**GS# 104-215 Jones Hall Interior Renovations
Mississippi University for Women**

Addendum No. 3

SHEET **E403**

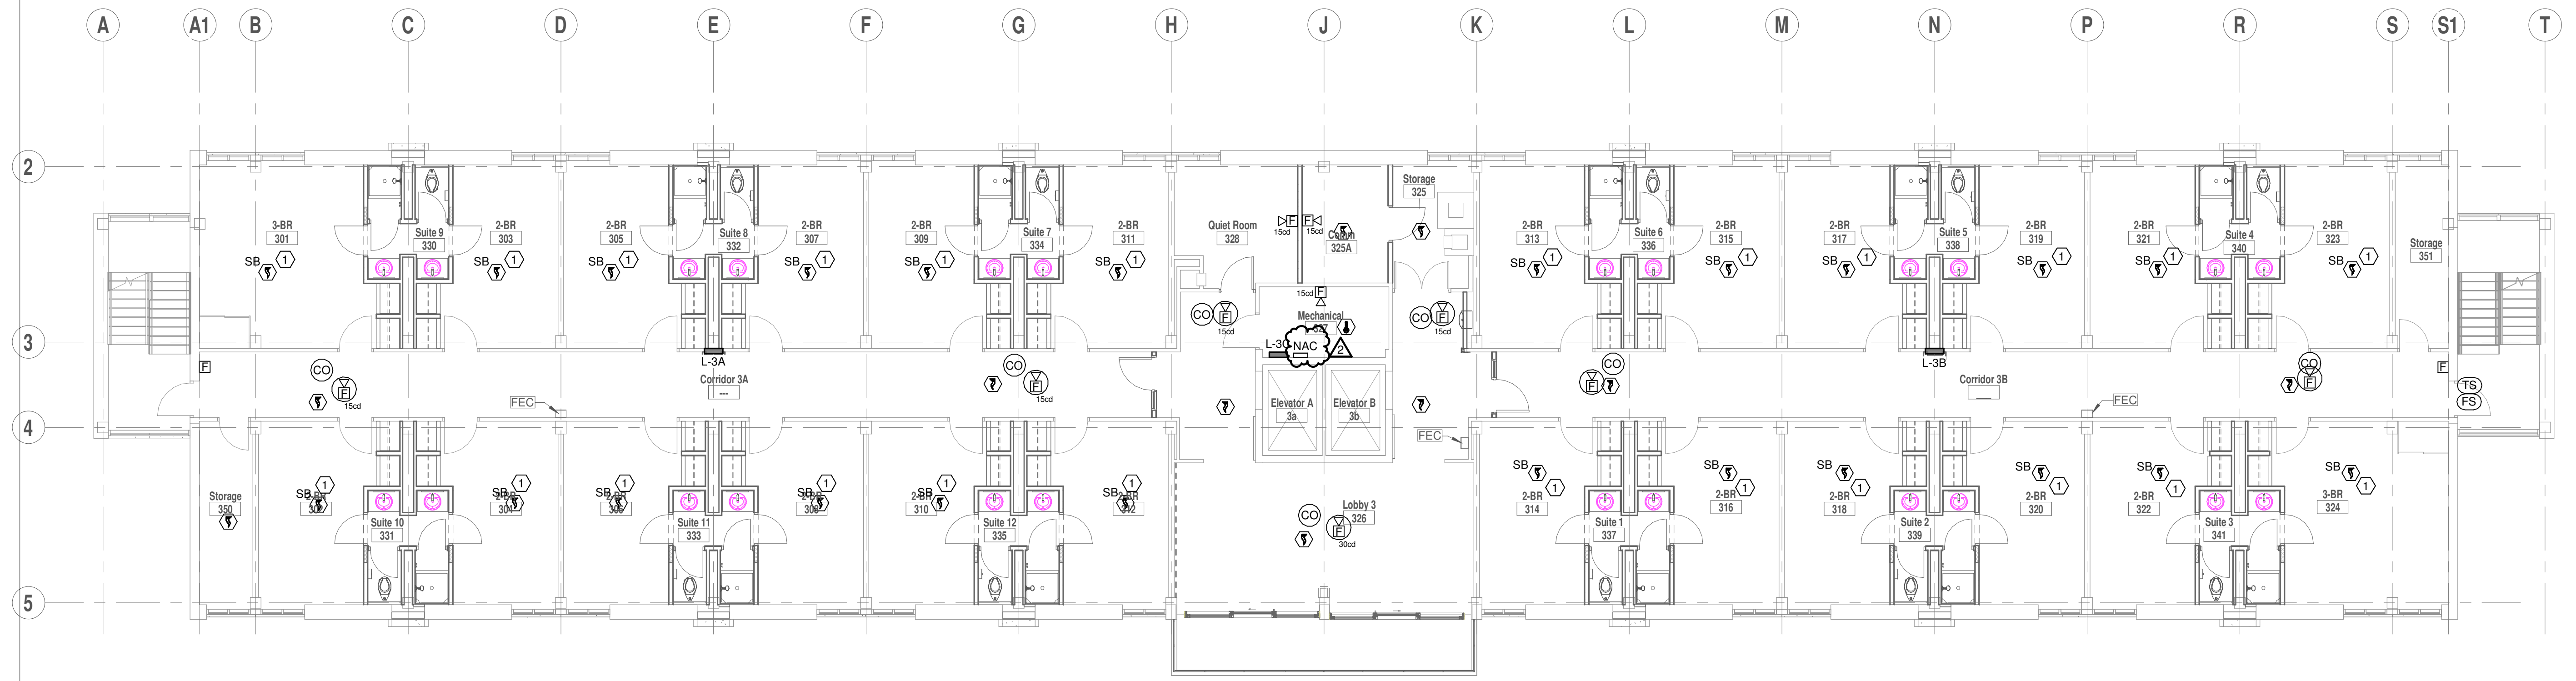
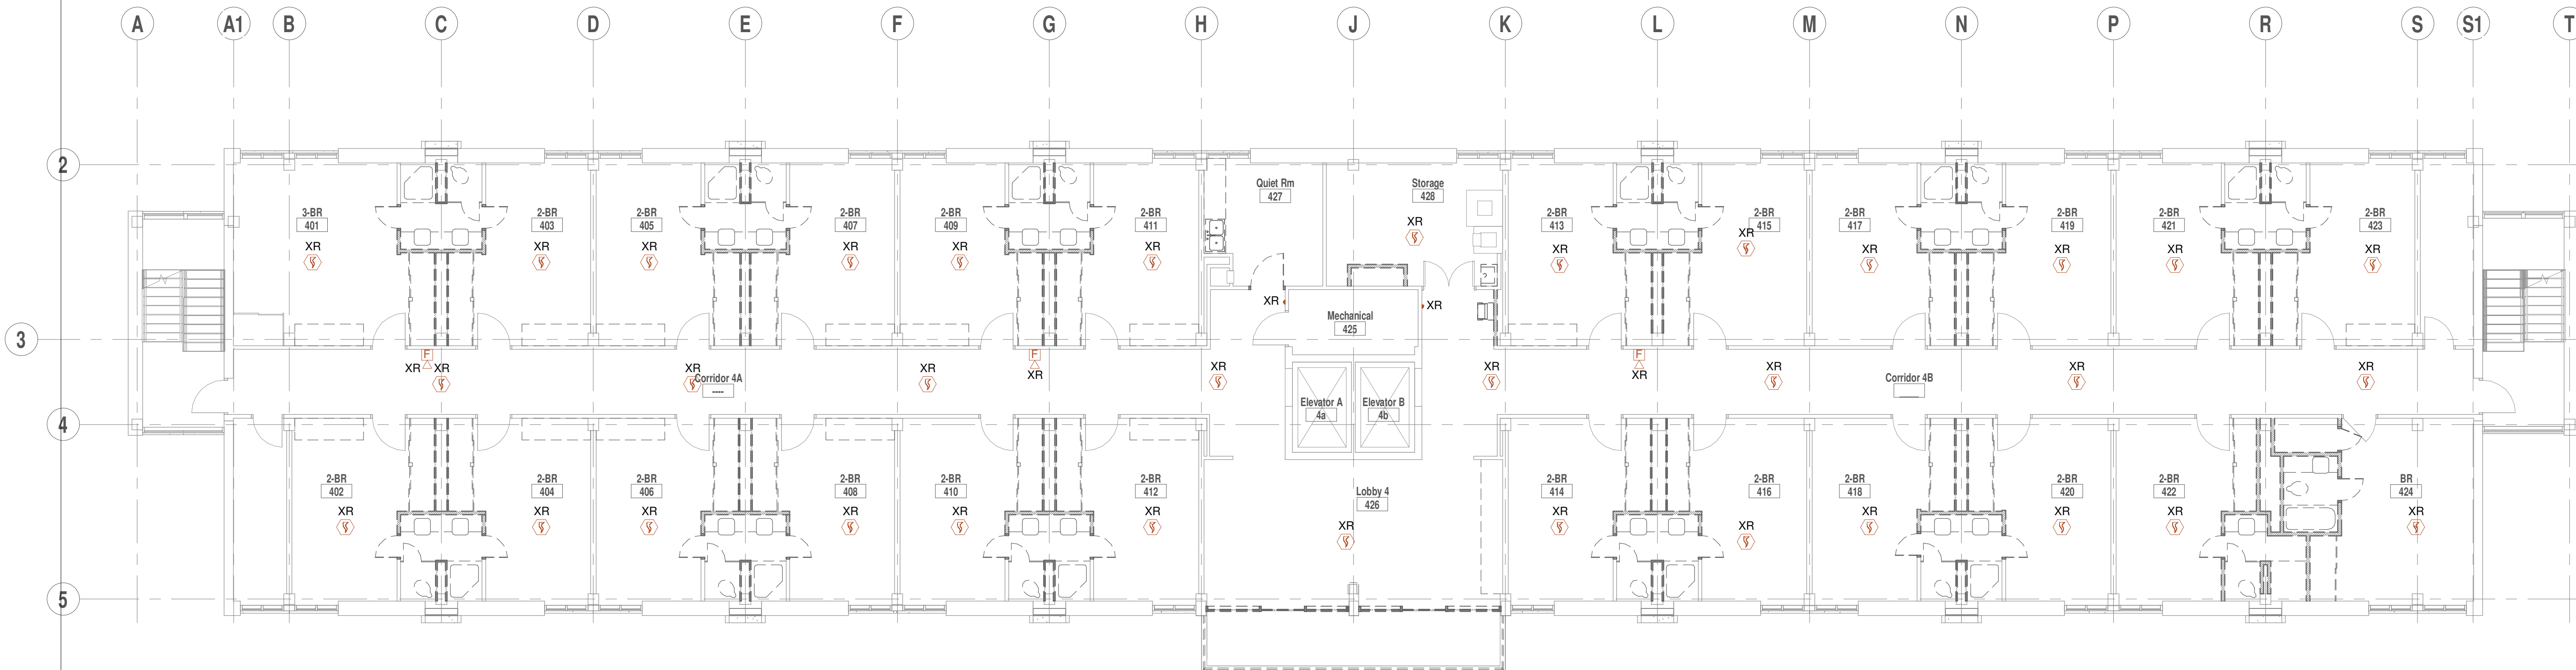
- q. Revise Sheet E402 and replace with attached Sheet E402. Revisions include adding NAC fire alarm panel to mechanical room.
- r. Revise Sheet E403 and replace with attached Sheet E403. Revisions include adding NAC fire alarm panel to mechanical room.

SHEET **E404**

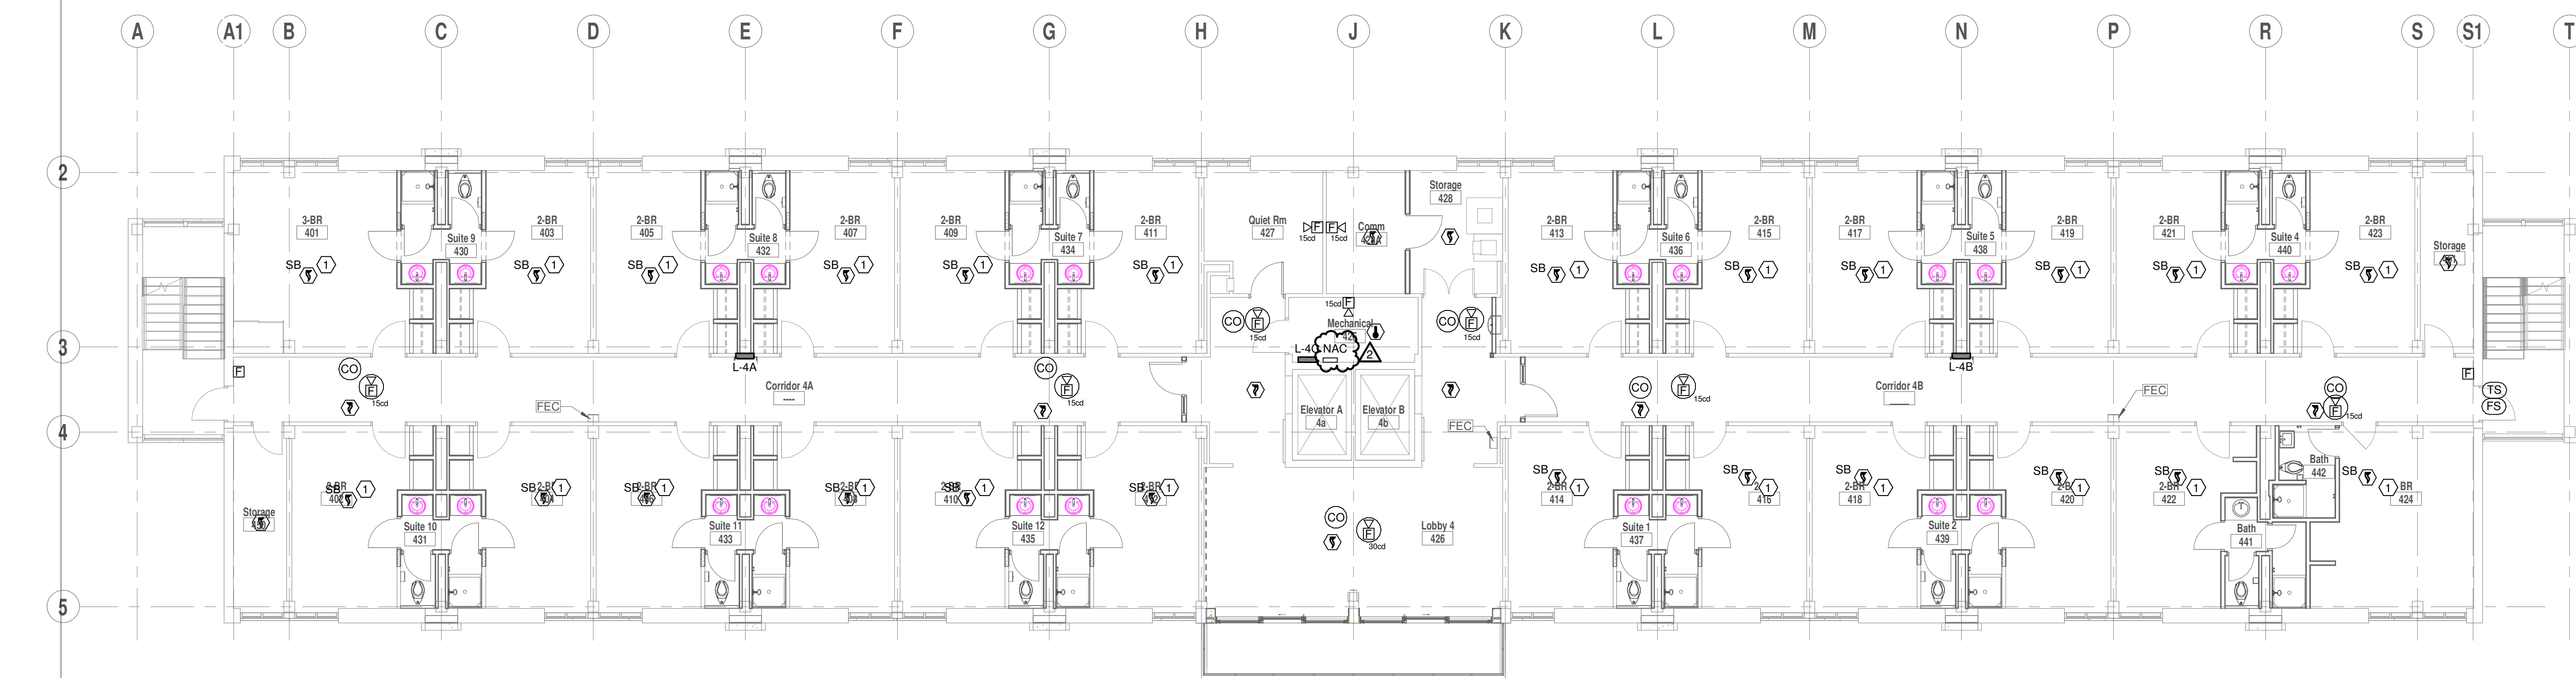
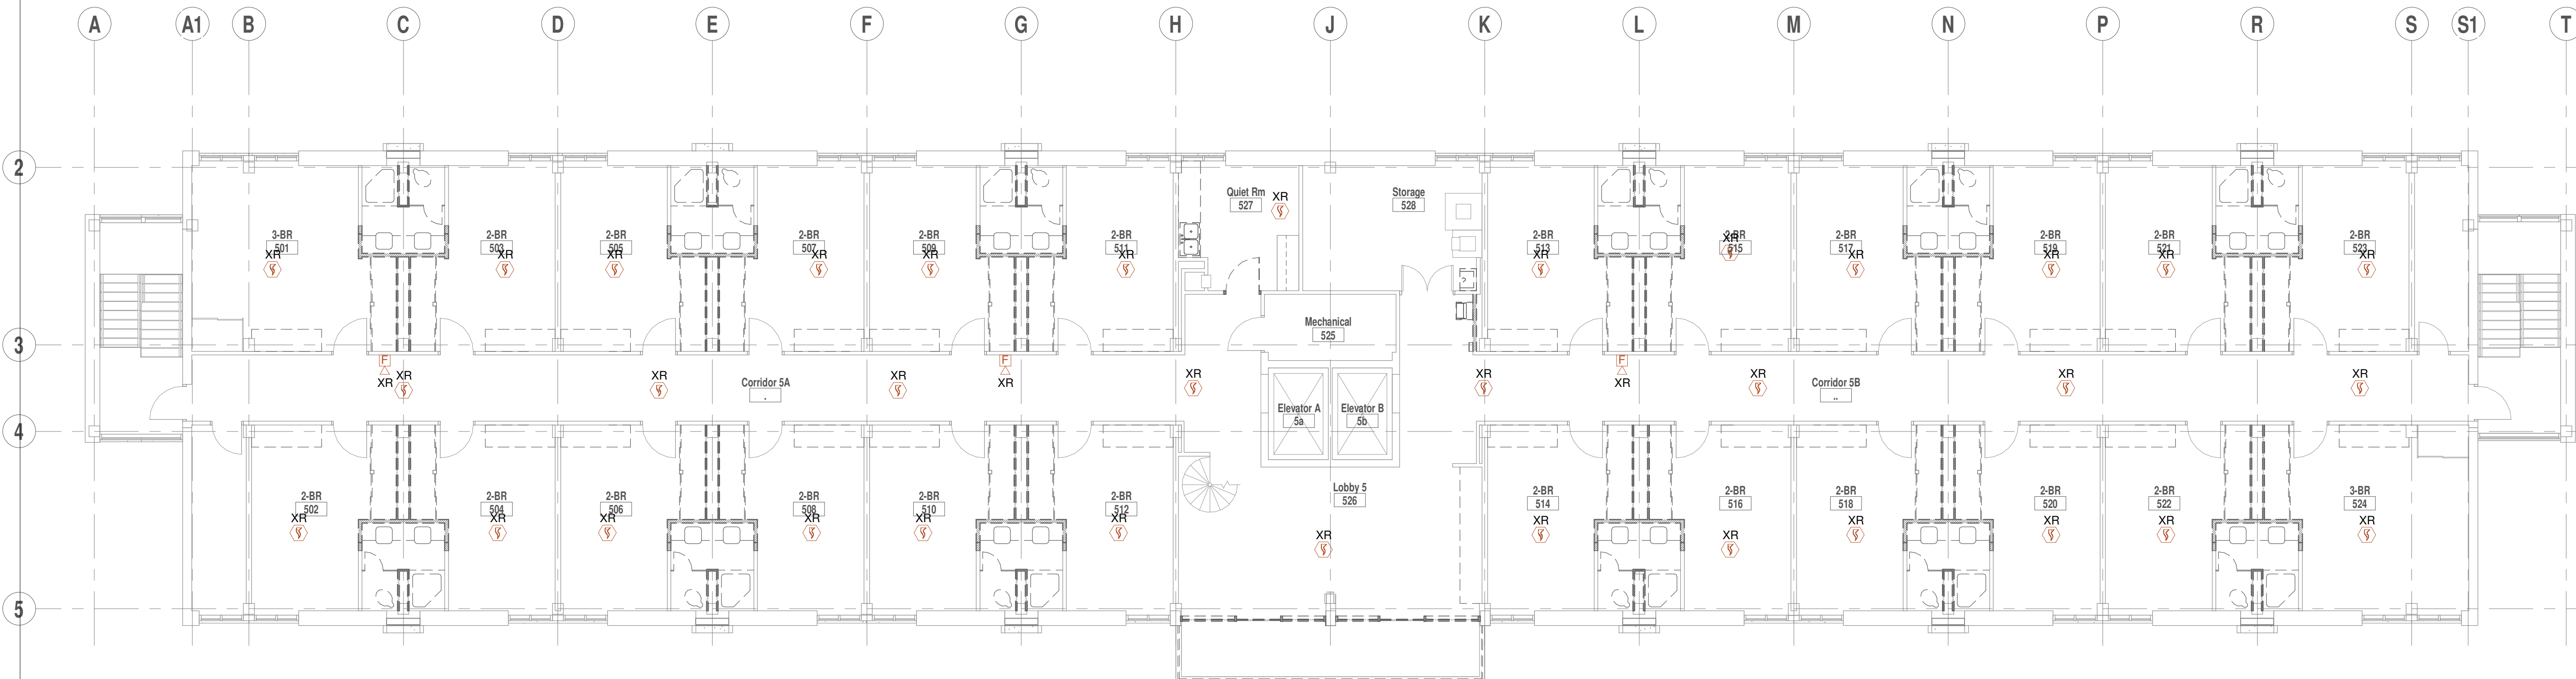
- s. Revise Sheet E404 and replace with attached Sheet E404. Revisions include adding NAC fire alarm panel to mechanical room.
- t. Revise Sheet E405 and replace with attached Sheet E405. Revisions include adding NAC fire alarm panel to mechanical room.
